ANDALEX
RESOURCES, INC.

Re: Andalex Resources, Inc. C/007/019
T17-001 Removal of Monitoring Points

APPLICATION FOR PERMIT PROCESSING

<input checked="" type="checkbox"/> Permit Change X	<input type="checkbox"/> New Permit	<input type="checkbox"/> Renewal	<input type="checkbox"/> Transfer	<input type="checkbox"/> Exploration	<input type="checkbox"/> Bond Release	Permit Number: ACT/007/019
Title of Proposal: T17-001 Removal of Monitoring Points Task ID# 5446						Centennial Coal Mine
						Permittee: UtahAmerican Energy, Inc.

G:\Current Drawings\BMC Tower Mine\Permit\Plate Renumbered\Plate 7-8 Water Monitoring Locations R4.dwg, Water Monitoring Locations, 4/25/2017 1:39:36

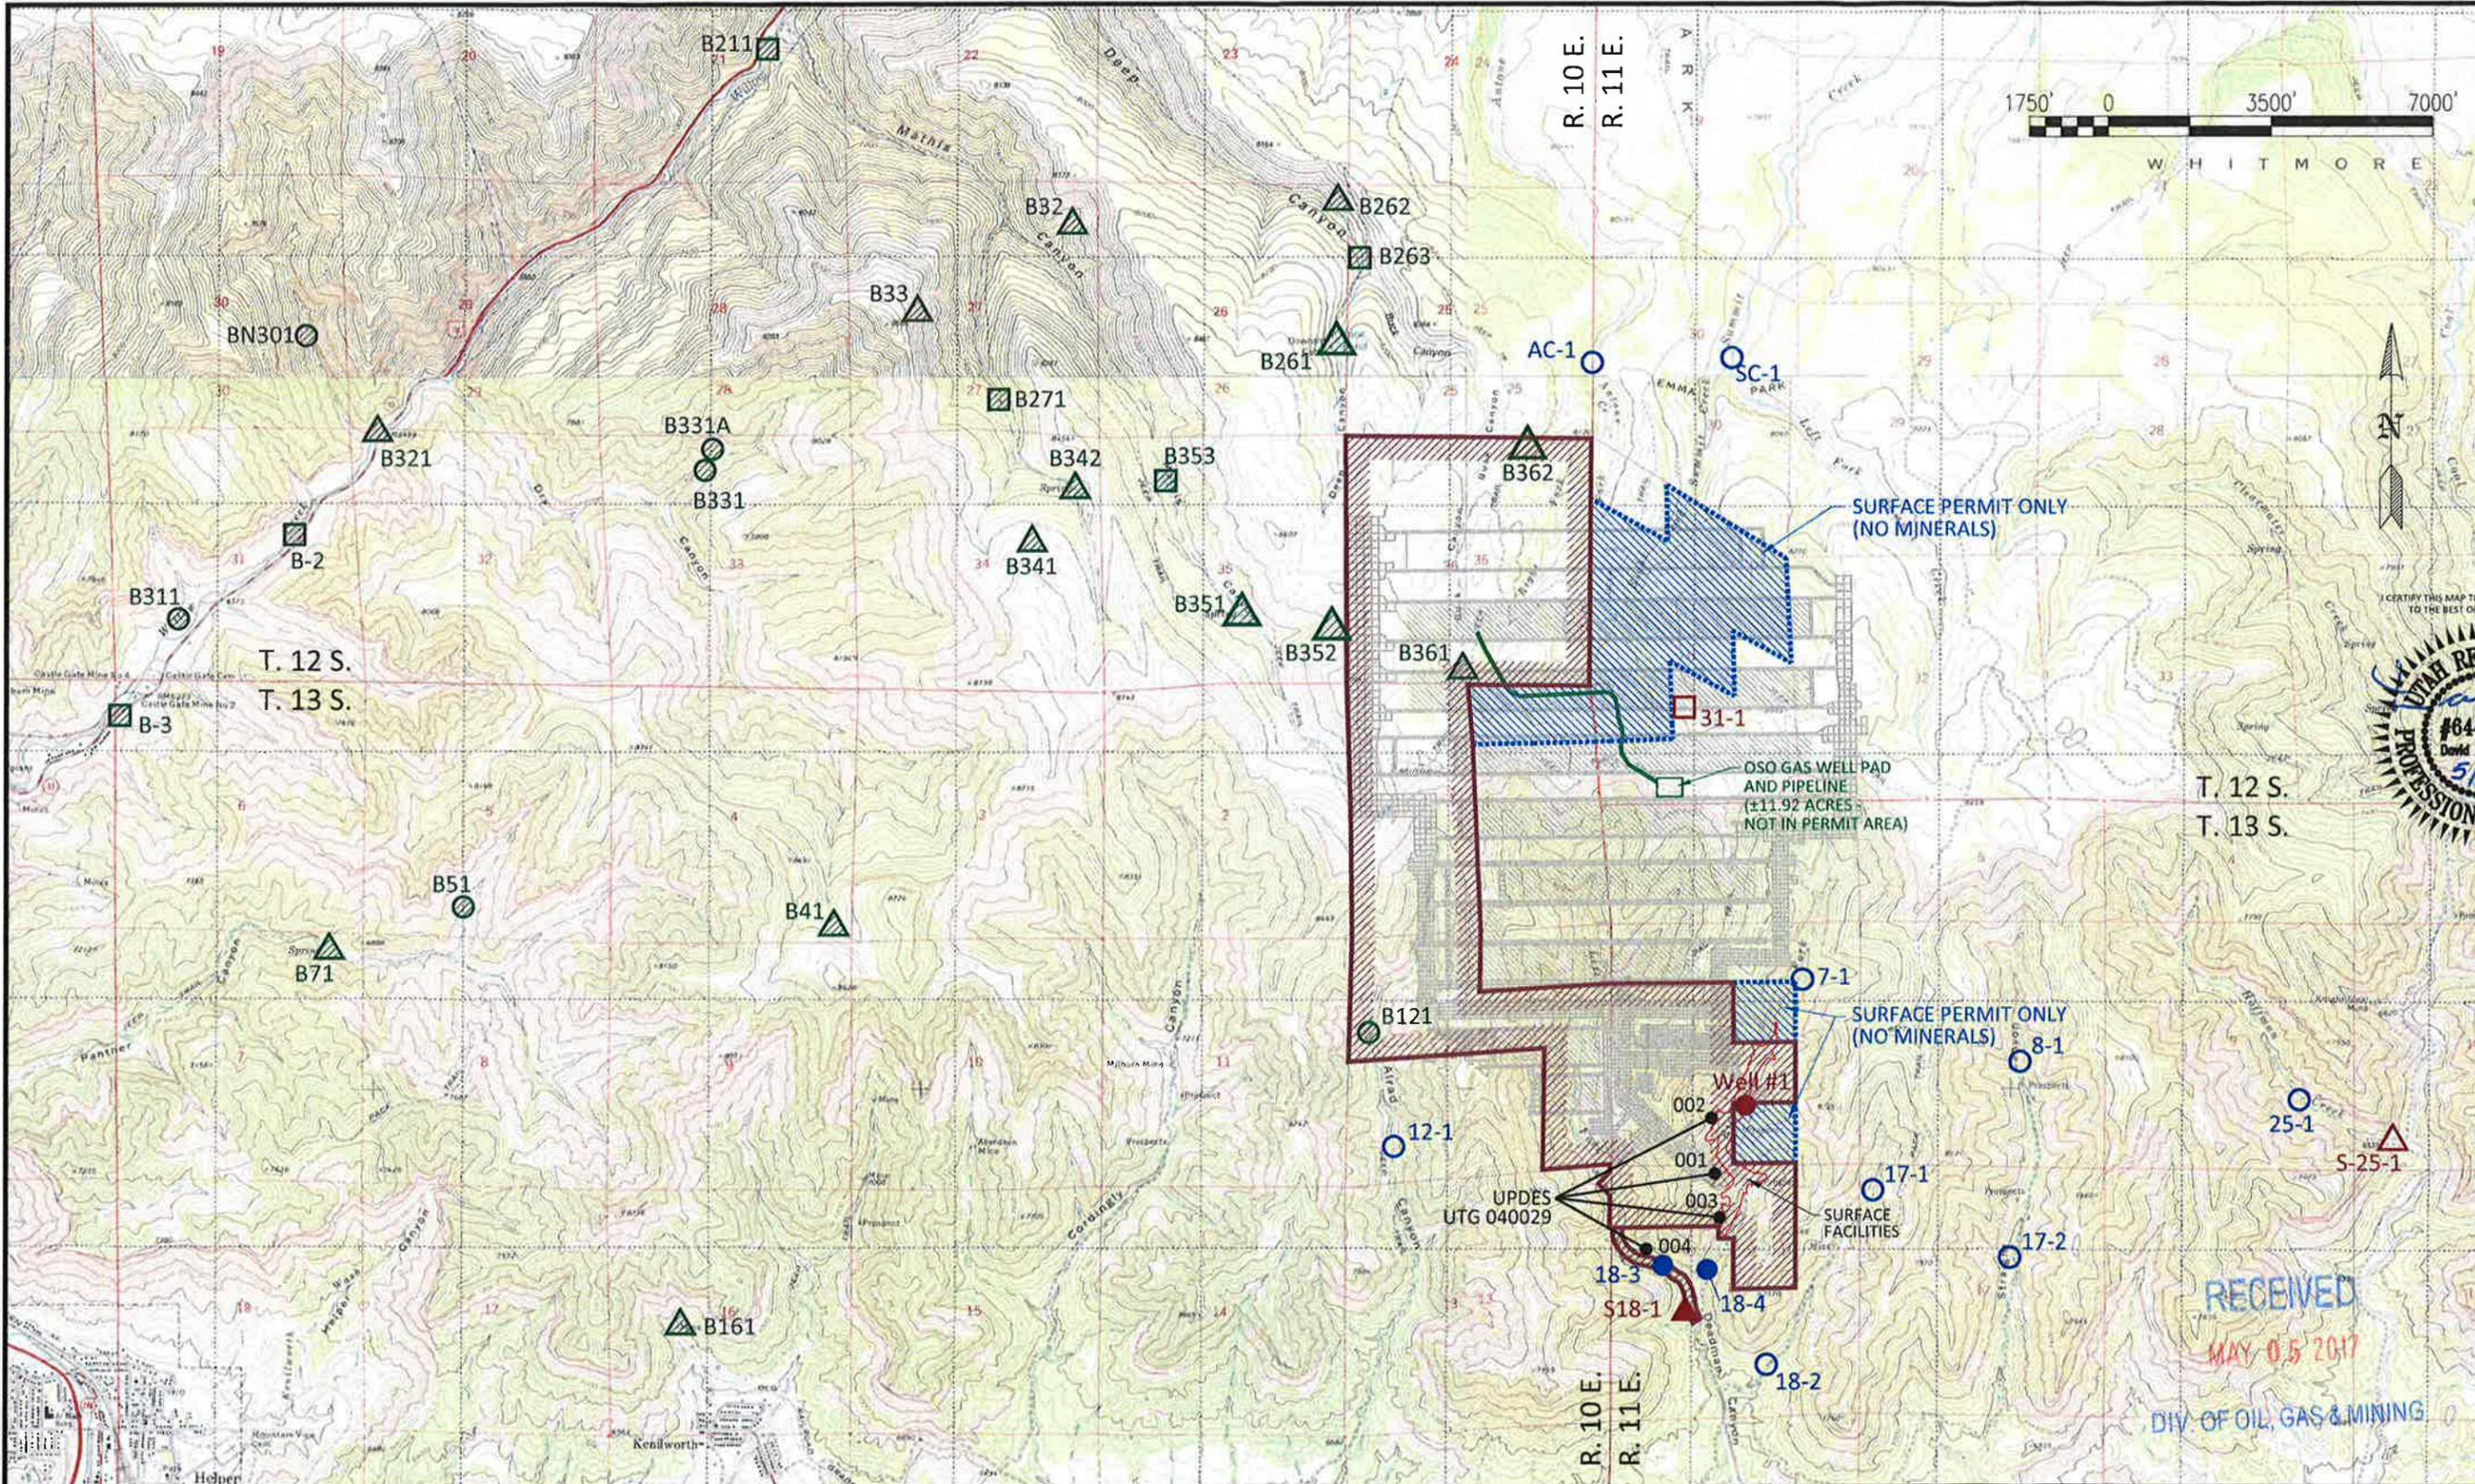
from this plan. Sites in Hoffman Canyon (S25-1 and 25-2), Straight Canyon (8-1 and 17-2), and Star Point Fork (17-1 and 18-2) will no longer be monitored. All of these sites are located within or near the eastern portion of the MRP boundary, and were never undermined. The closest mining was completed in 1993 and was about half a mile away from the sites, as shown on Plate 7-8. Further, site 12-1, located in Alrad Canyon in the southwest corner of the permit area, has been omitted from this plan.

In addition, there are numerous sites to the north and west of the permit area which have been omitted from this plan. As shown on Plate 7-8, a well monitoring station (B121), and stream site B263, B263, and B262 are located more than a mile away from the nearest underground mining, and stream sites AC-1 and SC-1 are three-quarters of a mile from the closest mine works. Other spring or seep sites (B 342, B271, B33, B361, B353, B341, B351, B352, B261, and B362) are similarly located well away from any recent mining. It should also be noted that at these sites the overburden is 3000' deep or greater. All mining in the Aberdeen Mine (Tower Mine) was discontinued in mid-2007, the mine has been shut down and sealed up, and there are not immediate plans to reopen the mine in the foreseeable future, until market conditions improve. Therefore, there is no continued need for monitoring.

Last, one other stream site and one stock pond site within the permit area is also being omitted from the monitoring plan. Ephemeral wash site 7-1 is located upstream of the main surface facilities and is typically dry. Because site 18-4 monitors the same stream further downstream and because operations have ceased, 18-4 is sufficient for tracking potential impacts in this drainage. Site 7-1 was never undermined, and the nearest second-mining (nearly one-half mile away) was completed in 1998. The stock pond site 31-1 is located over a inter-panel barrier pillar and was never undermined. The nearest second mining was done in 2004. Overburden cover at this location is 2500' and subsidence survey show that the area has not been subject to subsidence

Before the remaining Mathis lease is mined, monitoring will begin on sites B361 and B362 two(2) years prior mining.
